# STATE SIGNIFICANT DEVELOPMENT EDEN STREET ARNCLIFFE REDEVELOPMENT

On 30th July 2021, the Department of Planning, Industry and Environment (DPIE) requested comment in relation to the exhibition of an Environmental Impact Statement (EIS) prepared in support of a State Significant Development Application (SSDA) for the redevelopment of the NSW Land and Housing Corporation (LAHC) site at Eden Street, Arncliffe into a mixed-use precinct with retail and residential uses, involving both market and social housing as part of the LAHC's 'Communities Plus' Program.

## SUBMISSION

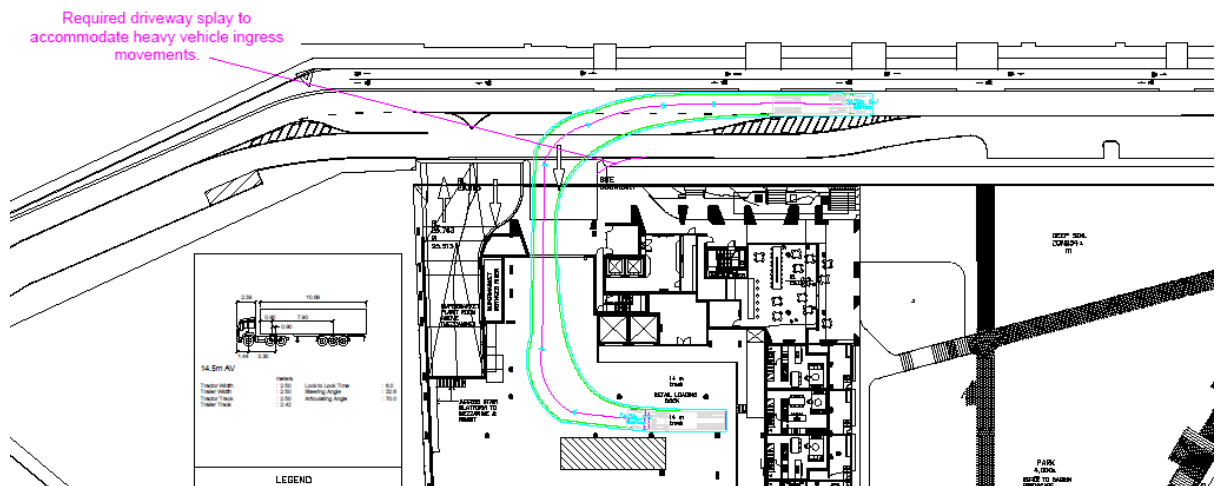
This development triggers the need for additional right turn movements at Allen Street or Burrows Road from the Princes Highway to provide connection to this development that avoids vehicles using Brodie Spark Drive. The applicant needs to liaise with Transport for NSW (TfNSW) to determine an appropriate design at the intersection of Allen or Burrows Street to accommodate southbound right-turn movements.

Modifying the Eden Street intersection also has the potential to negatively impact the Firth Street/ Forest Road intersection, which needs to be assessed and investigated to understand what impacts will be created.

Guideline concept plan - overall

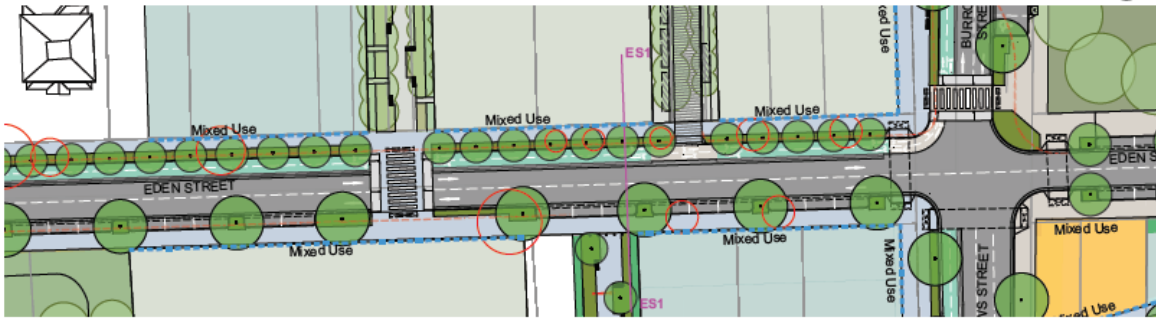
Refer to the below extract from the Arncliffe and Banksia Public Domain Plan & Technical Manual. The applicant shall refer to the full Manual for more detail.
